STATEMENT OF STAFF APPROVAL OF POST CERTIFICATION CHANGE HUMBOLDT BAY GENERATING STATION (06-AFC-07C)

On March 17, 2023, Pacific Gas and Electric Company (PG&E) filed a Post-Certification Petition for Changes in Project Design, Operation or Performance and Amendments to the Commission Decision (Petition) (TN#[249391](#)) with the California Energy Commission (CEC) requesting to amend the Humboldt Bay Generating Station (HBGS) Final Commission Decision (Final Decision).

ENVIRONMENTAL JUSTICE FIGURE 1

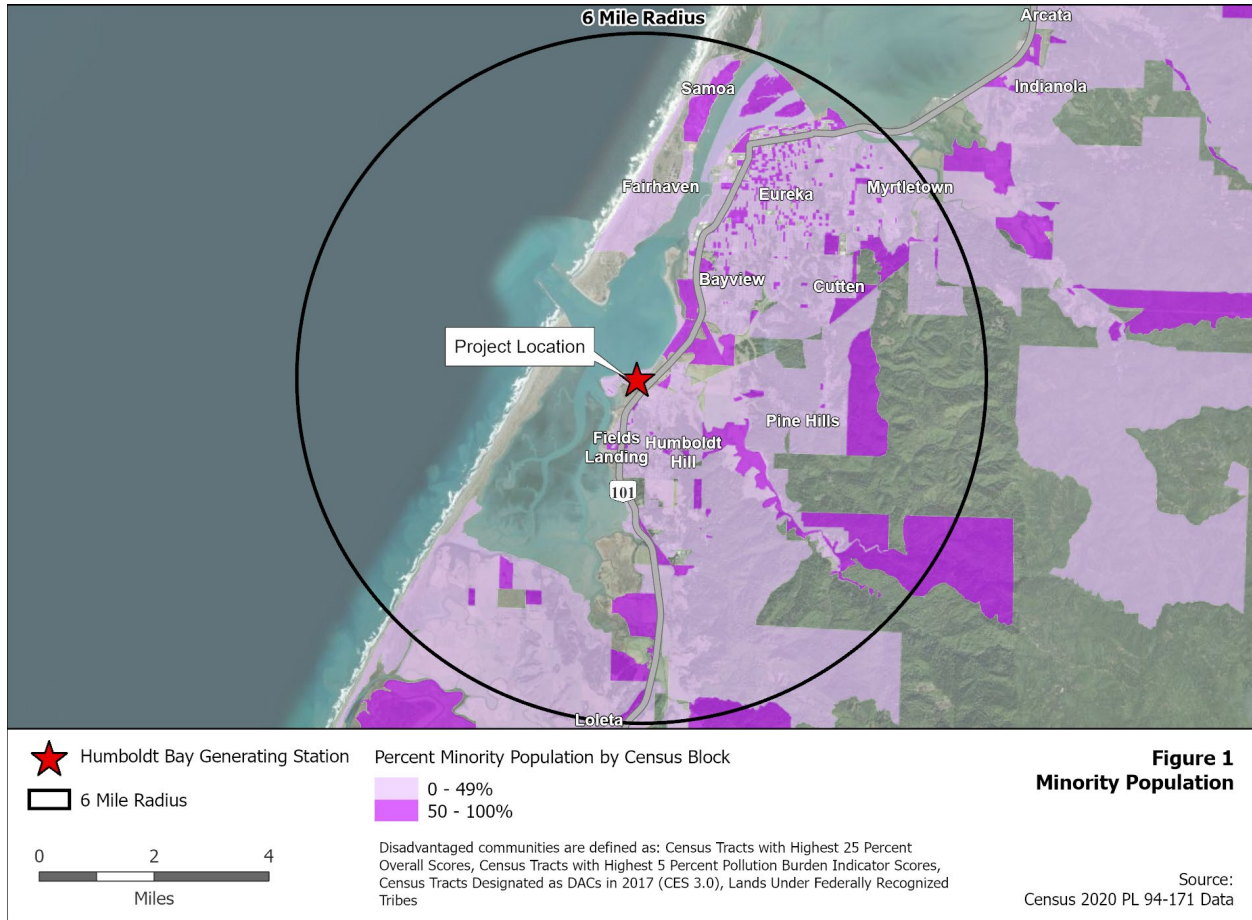
Environmental Justice Figure 1 shows 2020 census blocks in the six-mile radius of the Humboldt Bay Generating Facility with a minority population greater than or equal to 50 percent. The population in these census blocks represents an environmental justice (EJ) population based on race and ethnicity as defined in the United States Environmental Protection Agency's *Guidance on Considering Environmental Justice During the Development of Regulatory Actions*. Staff conservatively obtains demographic data within a six-mile radius around a project site based on the parameters for dispersion modeling used in staff's air quality analysis. Air quality impacts are generally the type of project impacts that extend the furthest from a project site. Beyond a six-mile radius, air emissions have either settled out of the air column or mixed with surrounding air to the extent the potential impacts are less than significant. The area of potential impacts would not extend this far from the project site for most other technical areas included in staff's EJ analysis.

ENVIRONMENTAL JUSTICE FIGURE 2

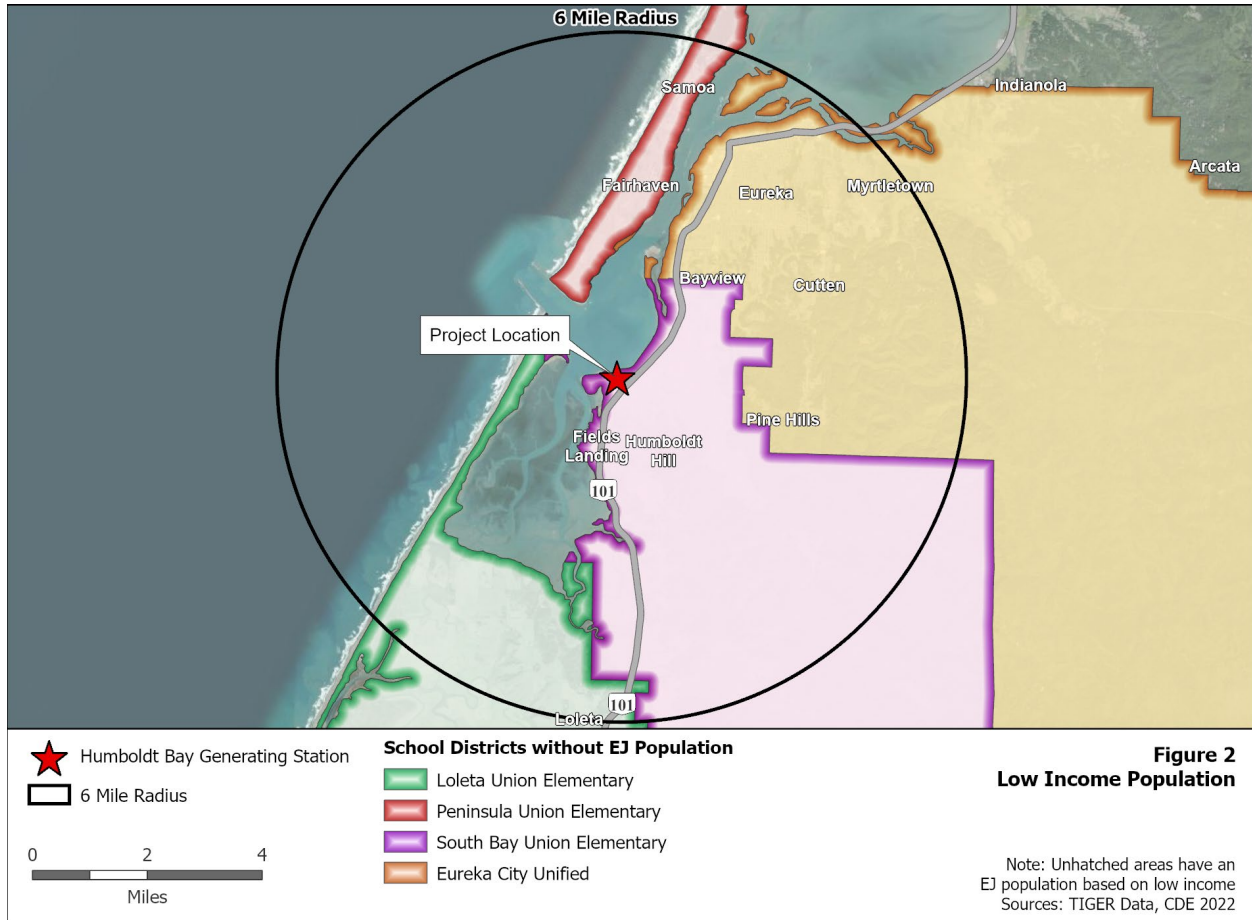
Environmental Justice – Figure 2 shows where the boundaries of the school district are in relation to the six-mile radius around the Humboldt Bay Generating Station site.
